MIL-S-19500/211B
AMENDMENT 4
02 March 1992
SUPERSEDING
AMENDMENT 3
28 February 1985

SEMICONDUCTOR DEVICE, DIODE, SILICON, POWER RECTIFIER
TYPES 1N3164, 1N3168, 1N3170, 1N3172, 1N3174, 1N3175,
1N3176, 1N3177, AND R TYPES, JANTX, AND JANTXV

This amendment forms a part of MIL-S-19500/211B, dated 18 May 1983, and is approved for use by all Departments and Agencies of the Department of Defense.

FIGURE 1. Physical dimensions for semiconductor devices.

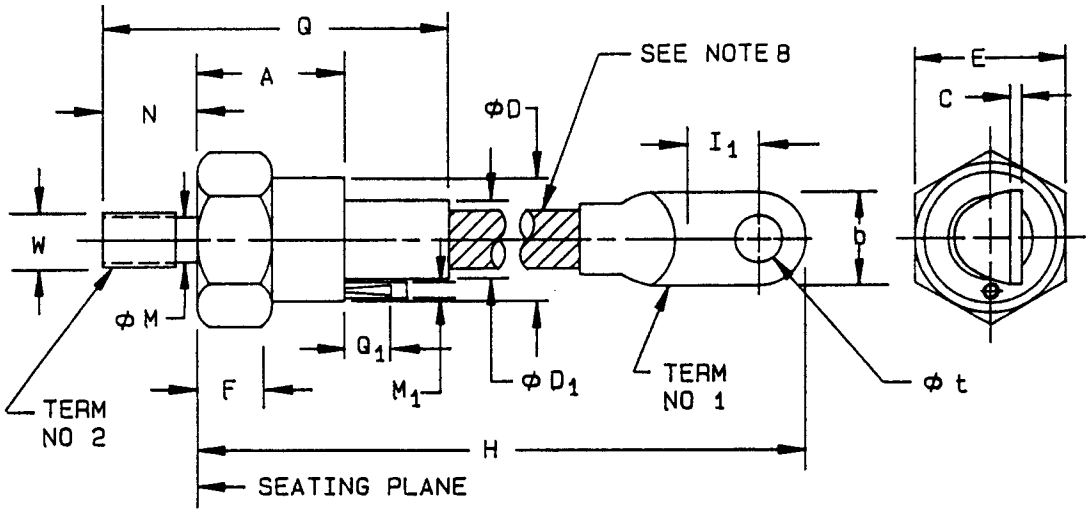
FIGURE 1: Delete and substitute the new figure 1 as printed below:

1. Metric equivalents are given for general information only.
2. Complete threads to extend to within 2-1/2 threads of seating plane.
3. 3/4-16 UNF-2A. Maximum pitch diameter of plated threads shall be basic pitch diameter .7094 (18.019 mm) ref. (Screw Thread Standards for Federal Services) FED-STD-H28.
4. Angular orientation of terminal and tabulation with respect to hex base is undefined. Square or radius on end of terminal is undefined.
5. A chamfer (or undercut) on one or both ends of hexagonal portions is optional.
6. Tabulation optional.
7. Minimum flat.
8. Flexible leads.

Letter	Dimensions				Notes
	Inches		Millimeters		
	Min	Max	Min	Max	
A		1.520		38.10	4
B	.530	.755	13.46	19.18	
C	.063	.172	1.60	4.37	
ØD		1.100		27.94	
$ØD_1$		.600		15.24	
E	1.218	1.252	30.94	31.75	
F	.250	.562	6.35	14.27	5
H	5.125	6.750	130.18	171.45	
I_1	.375		9.53		7
ØM	.660	.745	16.76		2
M_1		.125		3.18	6
N	.793	.828	20.14	21.03	
Q		2.30		57.15	
Q_1		.375		9.53	6
Øt	.265	.350	6.73	8.89	
W					3
